# Staff Report

## Adjustment

AD-01-19

# Good Shepherd Estates-Adjustment

**PRELIMINARY SITE PLAN & COVER SHEET**

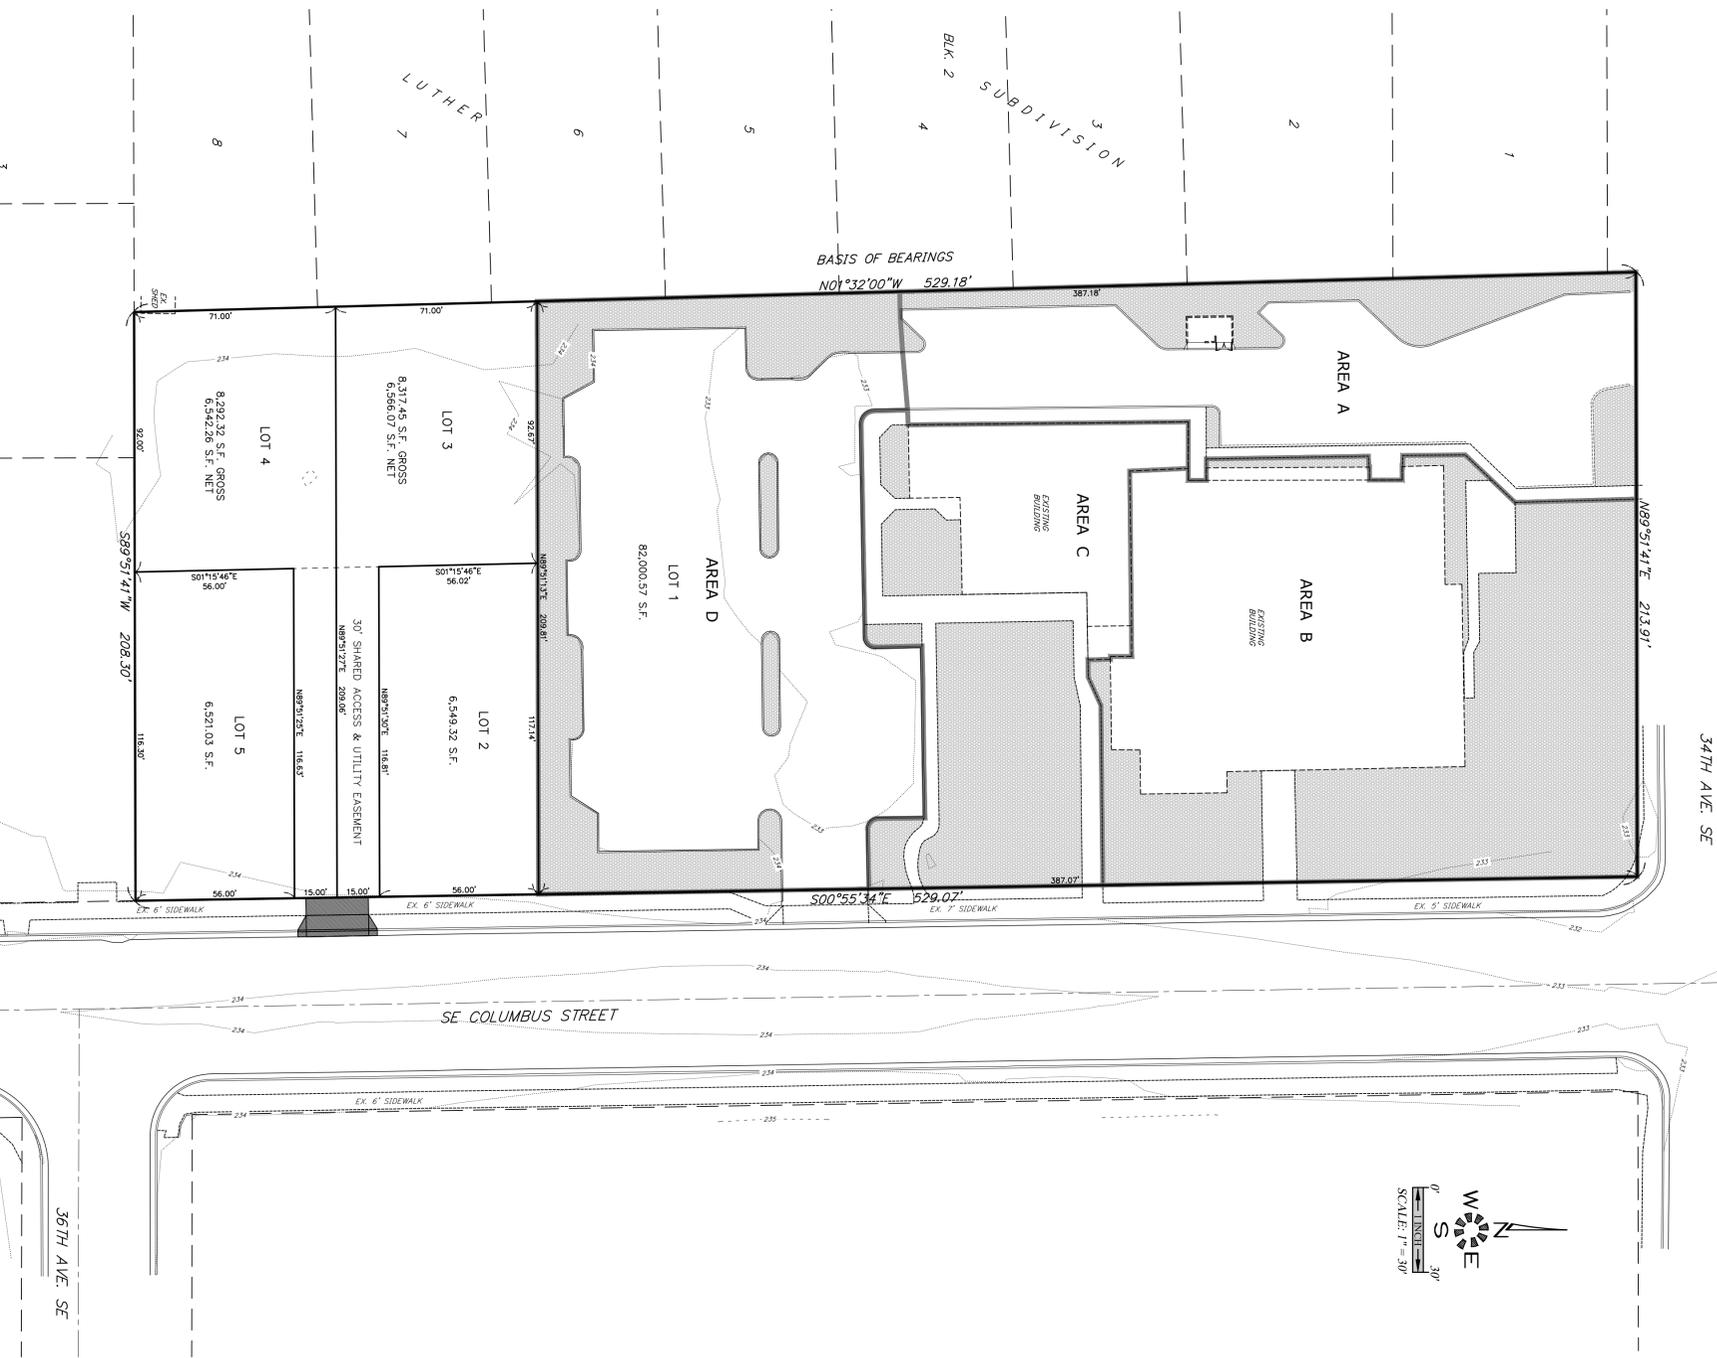
- 3.1 The RS-6.5 zoning district permits a maximum lot coverage of 60 percent. As indicated in the applicant's site plan (Attachment B), 64.4 percent of Lot 1 will be covered by impervious area. The applicant states in the written findings (Attachment C) that the proposal is to "increase the maximum lot coverage on Lot 1 to 66 percent." However, the applicant's site plan demonstrates that only 64.4 percent of the lot is covered by impervious surface. Therefore, staff find that the minimum adjustment necessary to address the unusual circumstance is 7.4 percent. Likewise, 7.4 percent is within the 10 percent threshold for an adjustment.

- 3.1 The request is to increase the maximum lot coverage on Lot 1 to 66 percent.
- 3.2 The minimum adjustment necessary to address the unusual circumstance is 7.4 percent for a total lot coverage of 64.4 percent. Therefore, the approval is to increase the lot coverage to 64.4 percent.
- 3.3 The approval is for no more than 10 percent of the numeric standard.
- 3.4 This review criterion is met without conditions.
